ASSESSMENT REPORT

Section 75W Modification

Trinity Point Mixed Use Development, Trinity Point Road, Morisset Park, Lake Macquarie Local Government Area MP 06_0309 MOD 5

Figure 6: Proposed Built Form

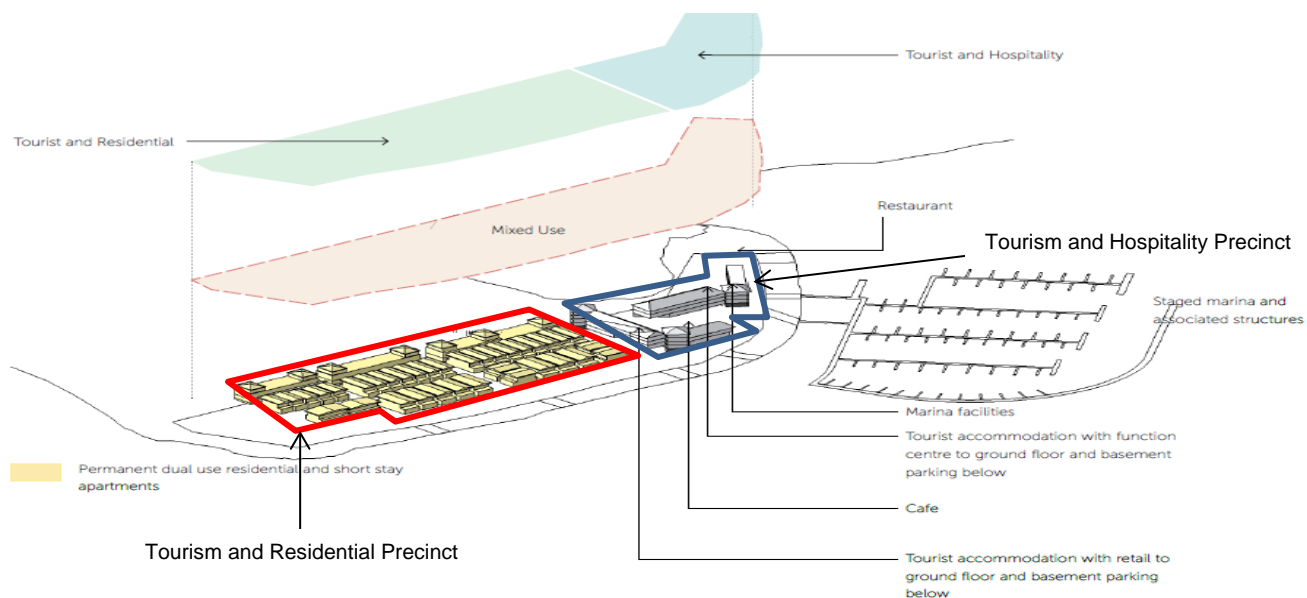
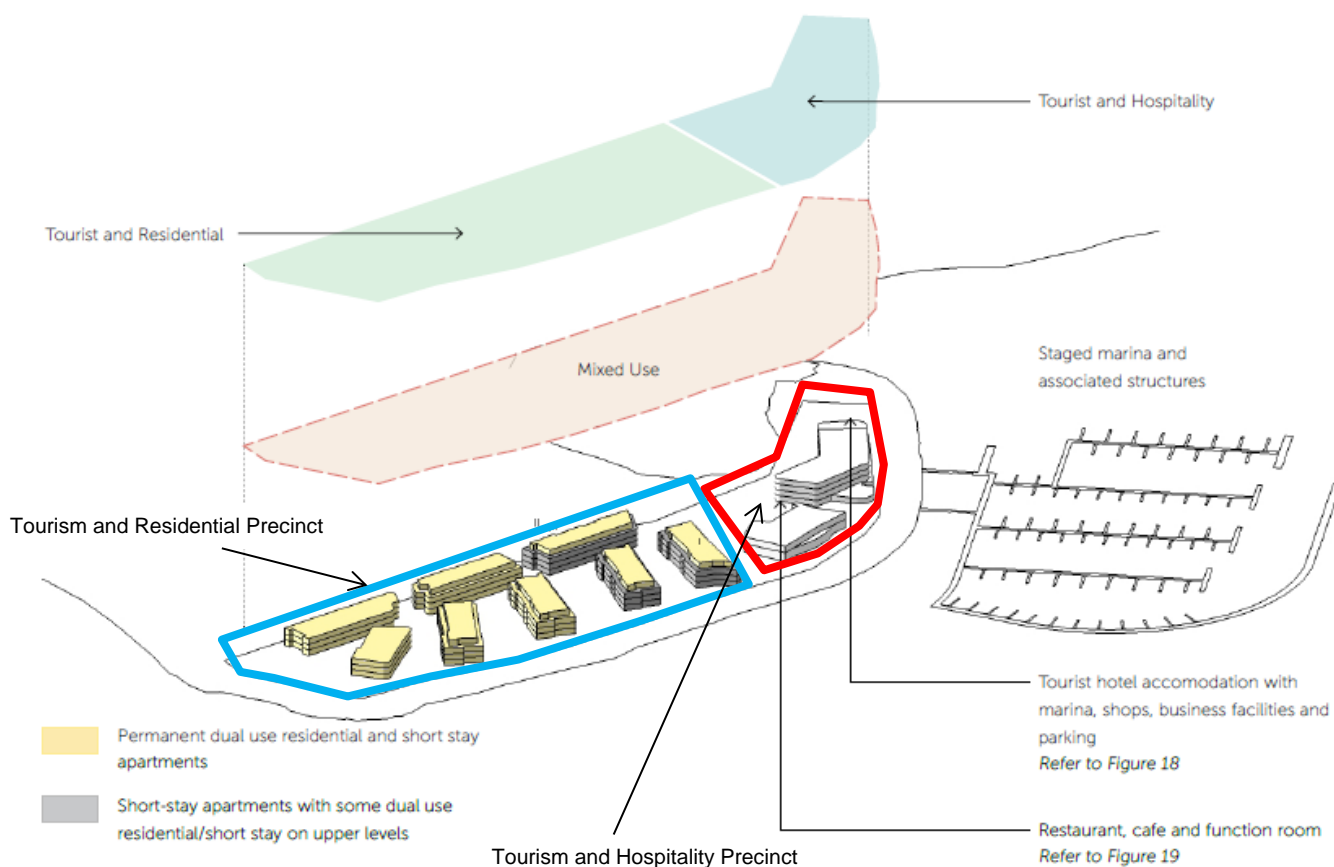
- reduction in the number of building envelopes from nine to eight;
- conversion of the attached and semi-detached dwellings to eight apartment buildings ranging in height between two and four storeys; and
- reconfiguration of the approved street network and public domain to reflect the proposed modifications to the building envelopes.

The proposed modifications will also result in an overall increase in the total gross floor area (GFA) approved within the northern and southern precincts (23,790 m² approved, 29,482 m² proposed). The proposed modifications to the Concept Plan are depicted in **Figure 6**.

Figure 7: Subject Site as Viewed from the Lake (Approved Concept)

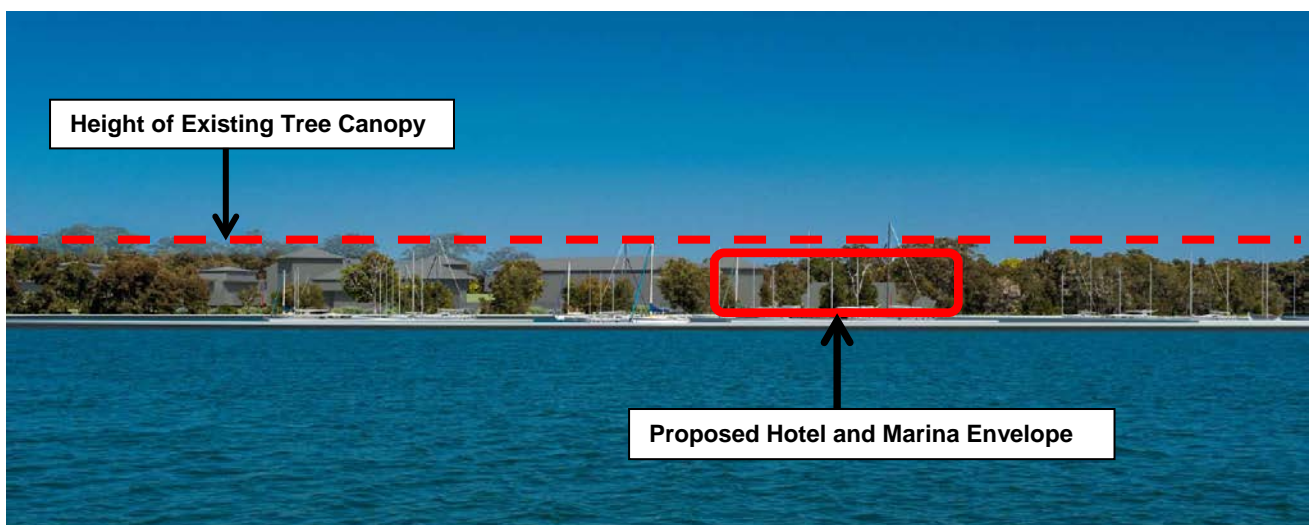
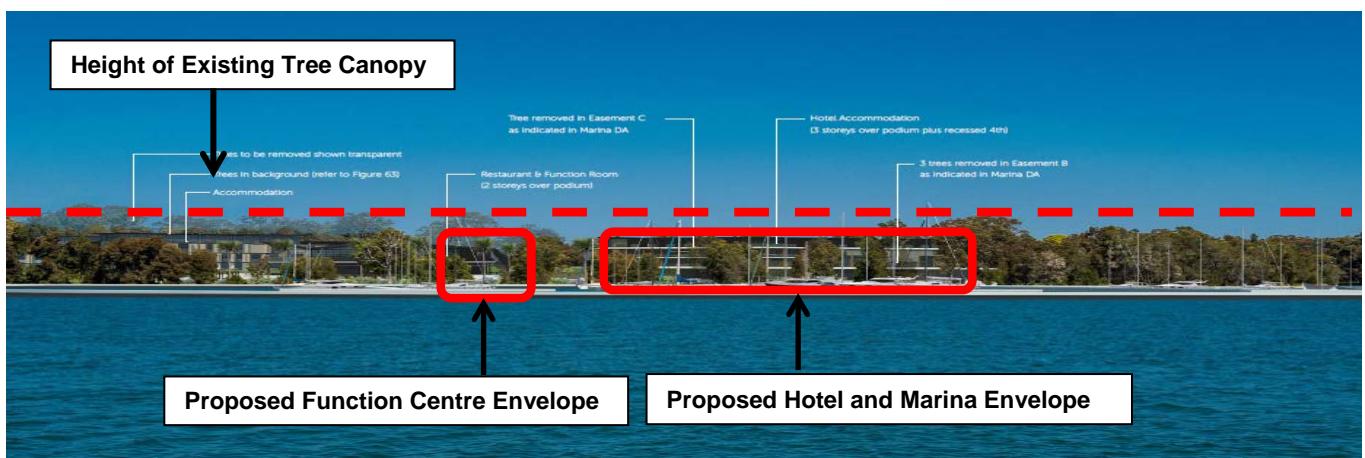
- the maximum height of the buildings within the Tourism and Hospitality Precinct will remain at four storeys, and the building envelopes have been sited to ensure all future built form will remain below the crown height of the existing vegetation as per the intent of the approved Concept Plan (see **Figures 7 and 8**);

Figure 9: Relationship of the Built Form with the Adjacent Residential Development

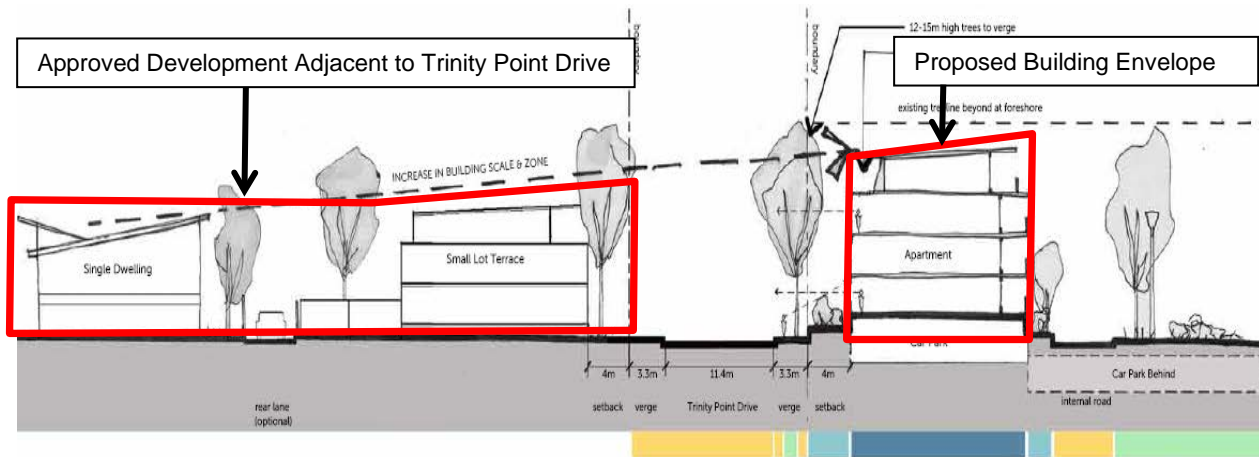
- the proposed building envelopes and building materials respond to the height and character of the developments approved along Trinity Point Drive, and will provide an appropriate transition between the urban character of the tourism and residential precincts and the adjoining residential development immediately west of the site (see **Figure 9**);

Figure 10: Comparison of Approved and Proposed View Corridors

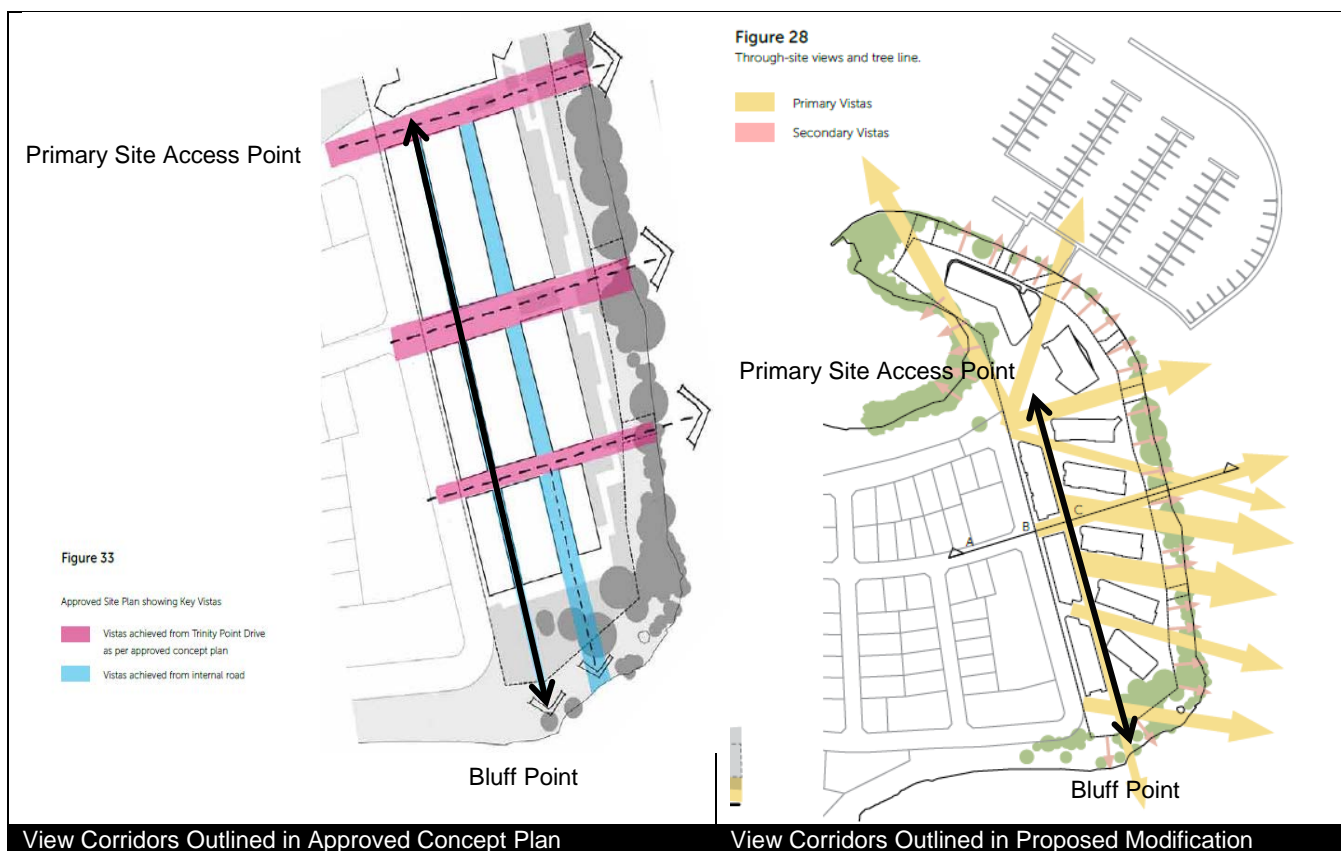
- the proposed block configurations will expand the approved east west view corridors and will establish a visual connection between Bluff Point and the Tourism and Hospitality Precinct (see **Figure 10**).

Figure 15: Comparison of Approved and Proposed Pedestrian Linkages

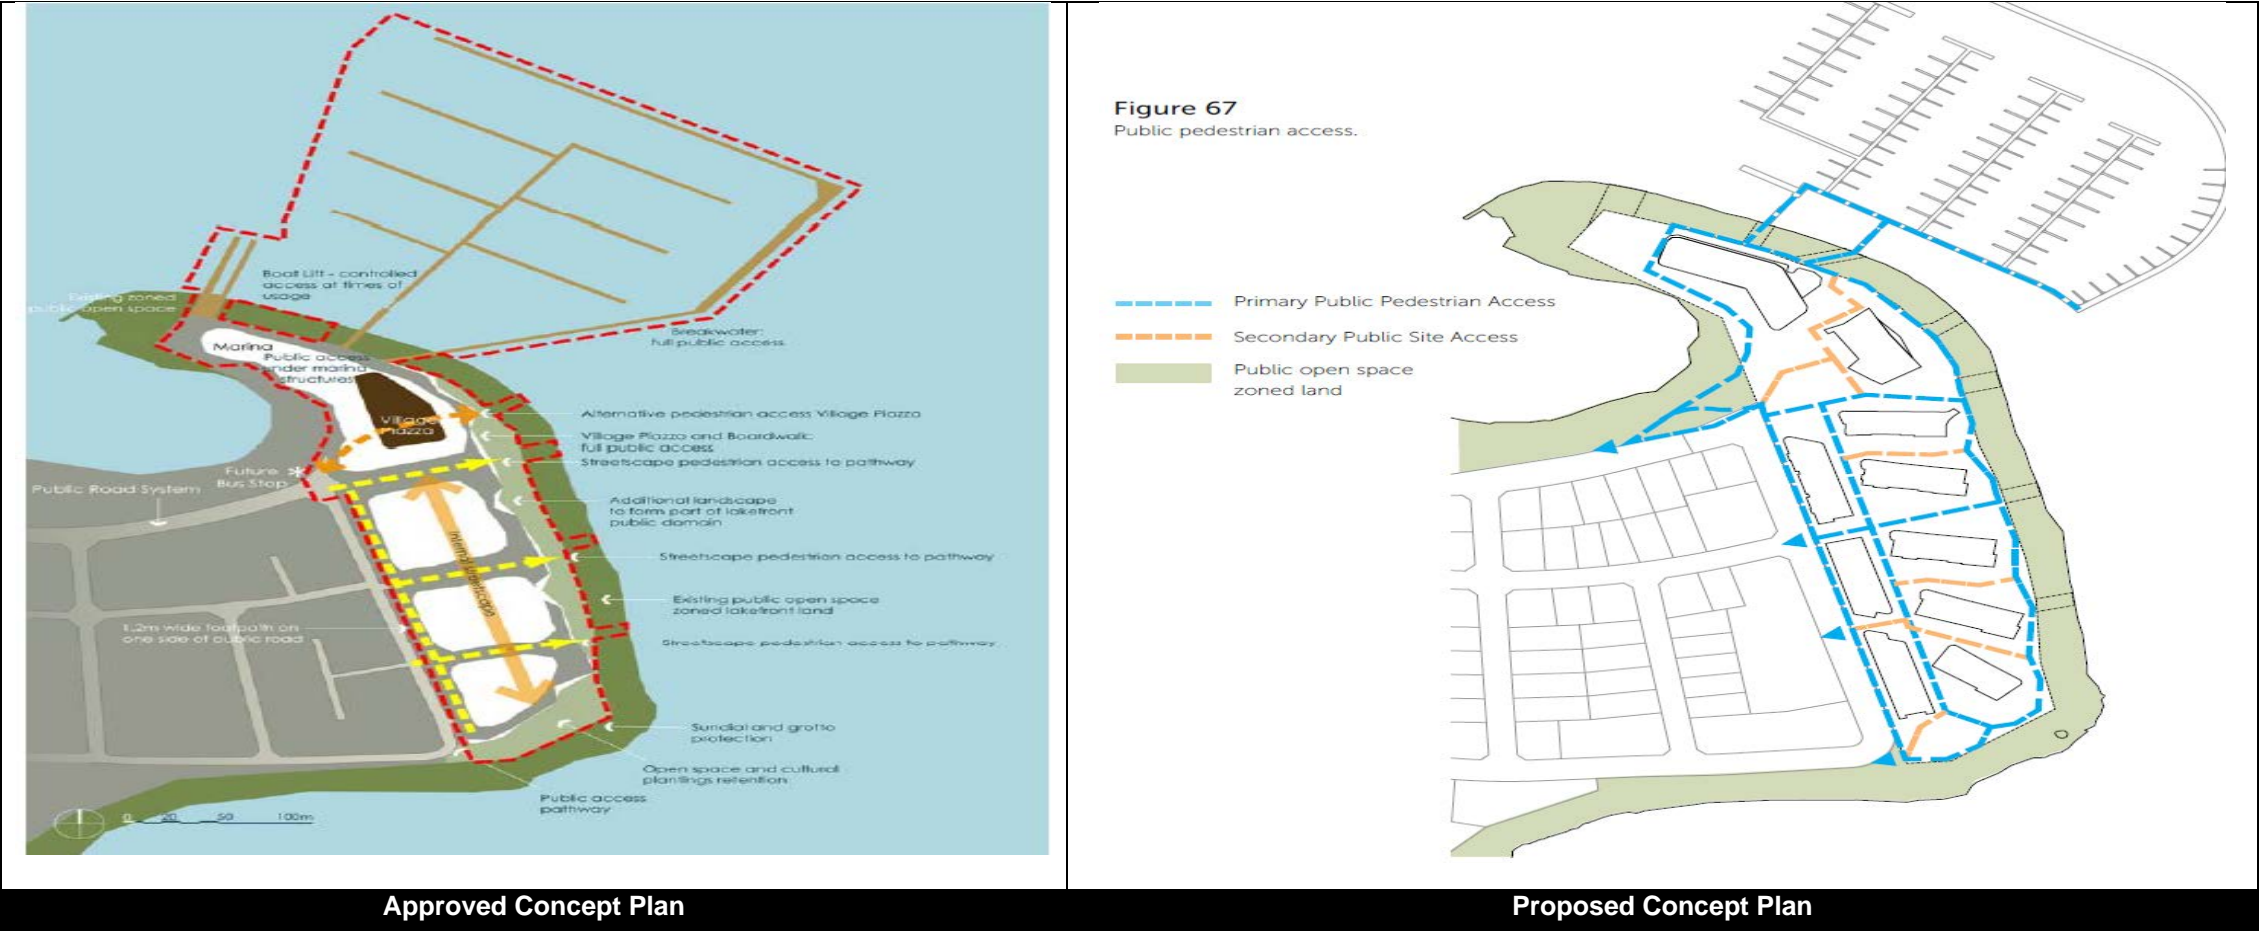
- the revised landscape concept will increase the extent of publicly accessible open space and will provide additional pedestrian links both within the site and to the foreshore reserve (23,100 m² approved, 25,600 m² proposed) (see **Figure 15**);

Figure 16: East-West Section through the Tourism and Residential Precinct Depicting the Interface between the Public and Private Domain

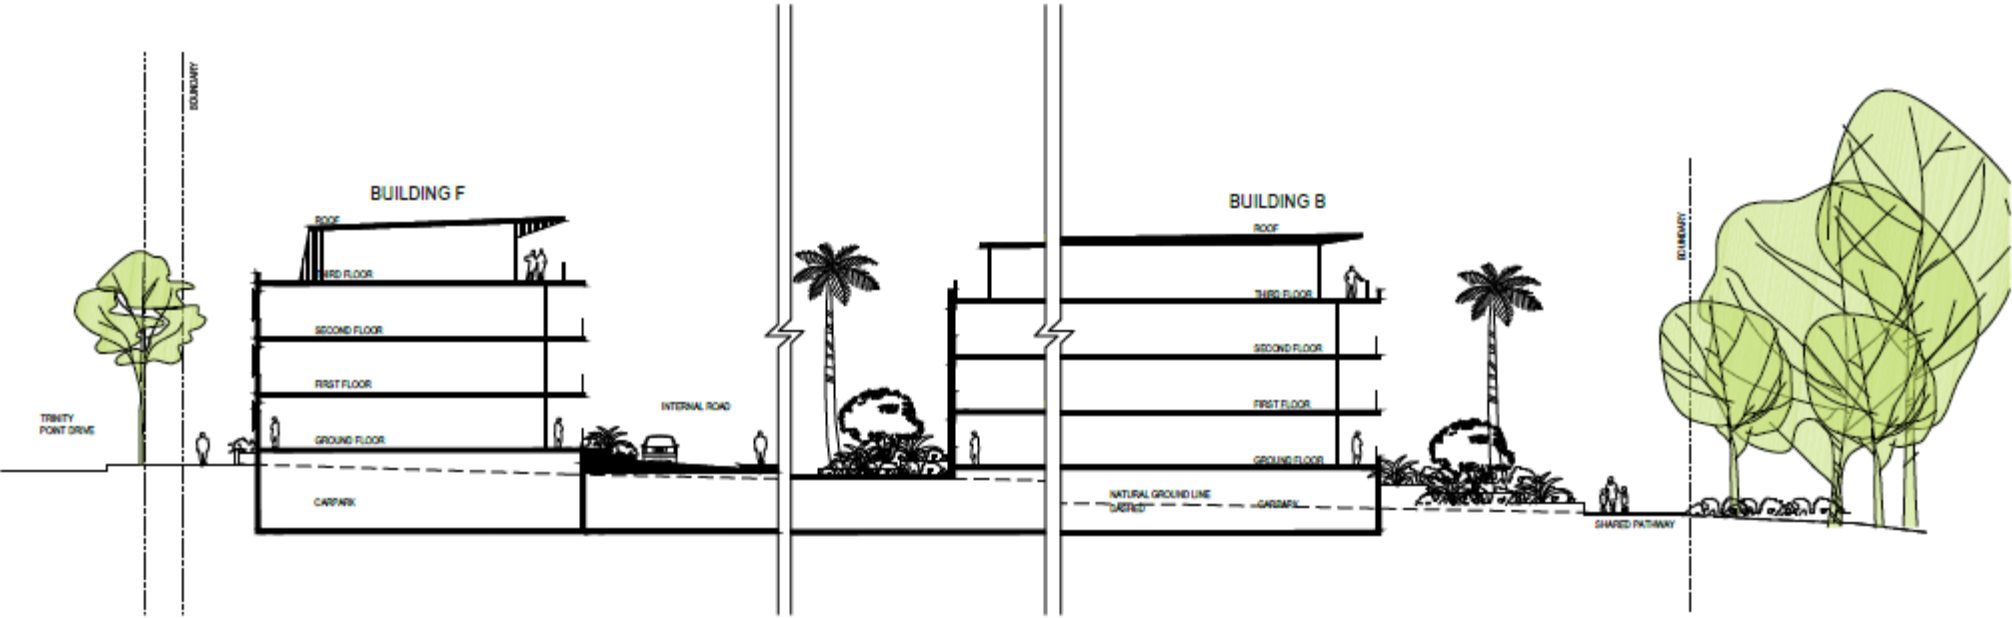
- the landscape concepts will ensure an appropriate transition between the public and private realm; and
- the sections provided to support the proposed modifications demonstrate that there will be a high degree of passive surveillance within the public domain to promote casual interaction between residents and visitors to the site (see **Figure 16**).
